Assessment of the fire performance of external wall systems for use on high rise buildings as featured on the Middlewood Locks project

Document Reference: 383476

Reference: Middlewood Locks project

COMMENTS.

Figure 1 Sample drawing of wall build up and fixings

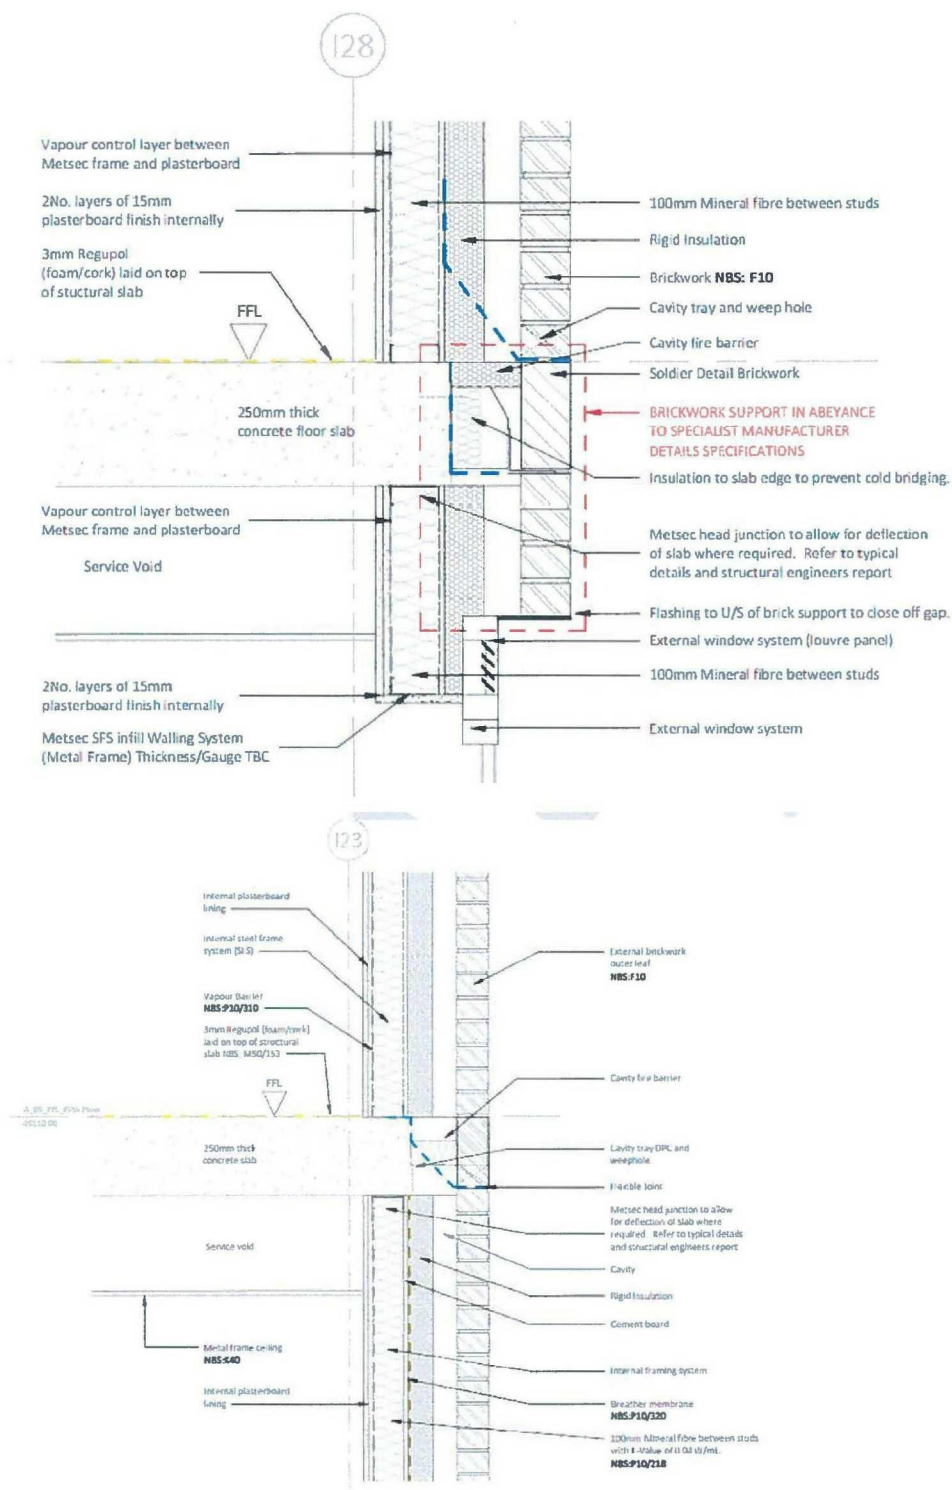
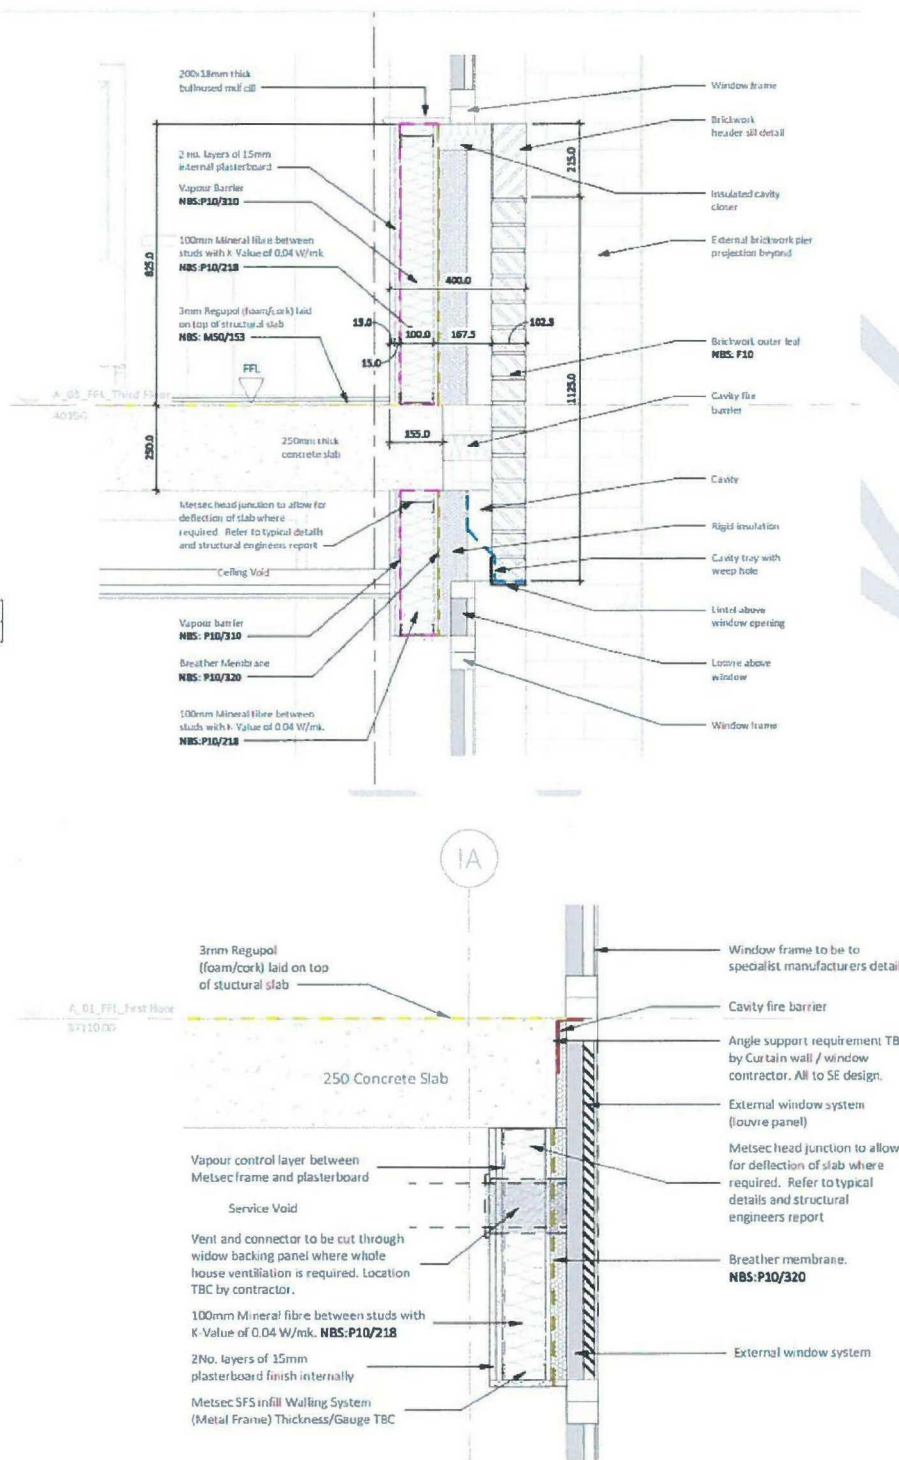
VAPOUR
CONTROL
LAYER

VAPOUR
CONTROL
LAYER

→ refer to front page wall
build up

refer to front
page for wall build up.
